Assessment Officer Report

PA2403110 – 101 Cremorne
Street, Cremorne

Officer Assessment Report
Development Approvals & Design

Figure 9 – Shadow diagrams showing extent of overshadowing at the September equinox between 10.15am and 10.45am (Source: Discussion plans).

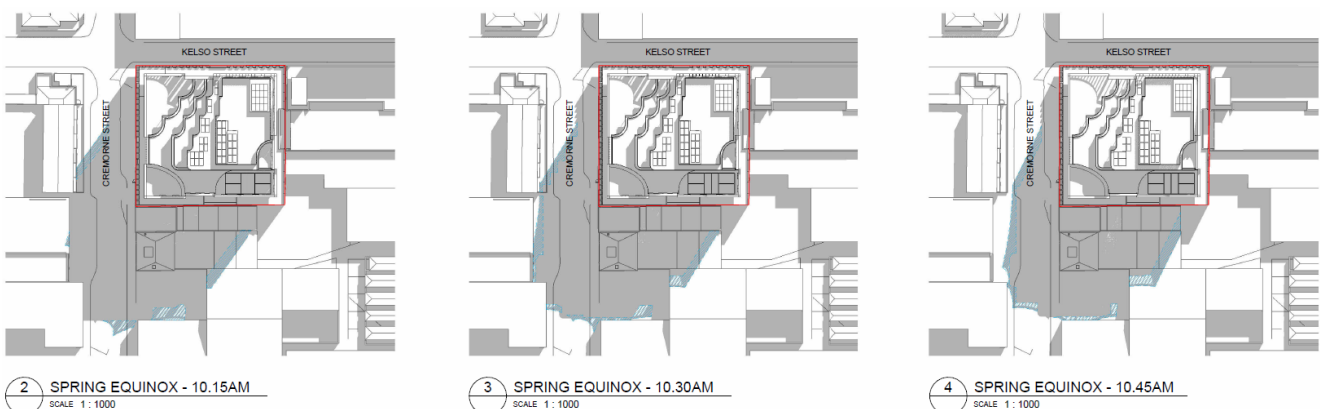
77. The proposal will meet the proposed DDO51 footpath overshadowing control, as the western footpath of Cremorne Street will be generally clear of overshadowing from 11am on 22 September.
78. The proposal will overshadow the east facing balconies/facades of 1-2 dwellings on the opposite side of Cremorne Street, but there will be no overshadowing from 10.45am onwards. There will be no overshadowing to the primary rear balconies. The council was satisfied the overshadowing of these dwellings was at a reasonable level. It is further noted that some of the shadow will be from the proposal’s glass curtain façade feature, which will be a ‘lighter’ shadow.

79. Courtyards of dwellings east of the site, at 98 Dover Street, will receive additional overshadowing in the afternoon. These dwellings, however, also have large north facing windows and balconies, which will continue to receive sunlight. Also as discussed earlier, these dwellings are 'non-conforming' uses and there is less amenity expectation in commercial zones for such residential uses. Notably, the council also was satisfied with the level of overshadowing of these dwellings.

Figure 19: Landscape plan showing vines planted on (left to right) west and north building elevations (Source: Application)

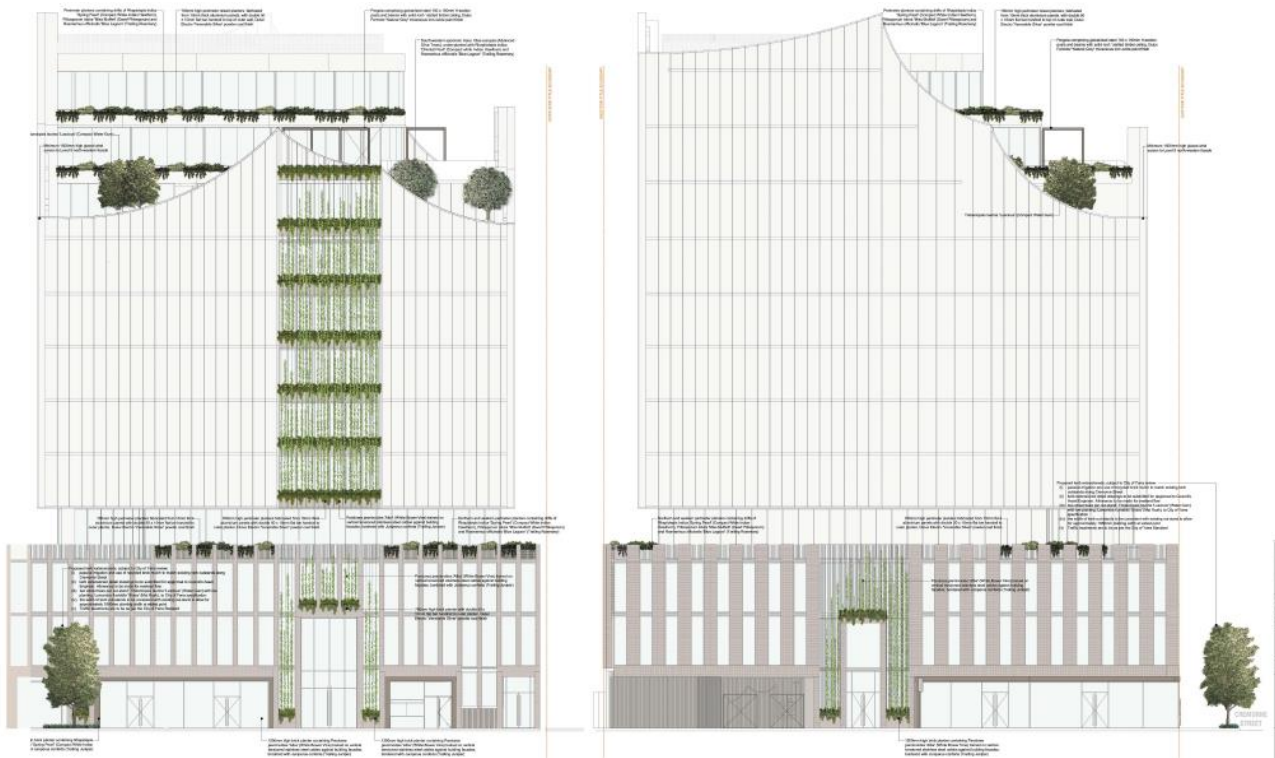
119. In addition to the ground level landscaping, the landscape plans show:
 - Level 3: terrace gardens on the north and east sides of the building with open seating areas;
 - Level 9: 'clubhouse' level with sport zone, outdoor cinema and larger open seating areas, also with terrace garden landscaping including trees, primarily on the west and south sides of building;
 - Level 10: terrace gardens with outdoor seating on the west and south sides of building; and
 - Level 11: open seating areas with planters on the west side of building.

120. The council have reviewed the plans and did not request any changes to landscaping within the site, other than removal of the ground level planter boxes in Cremorne Street, as discussed earlier.
121. Conditions will be included in the permit to ensure the landscaping concepts are delivered, including the vertical landscaping that provides a 'green' feature to the north and west facades.
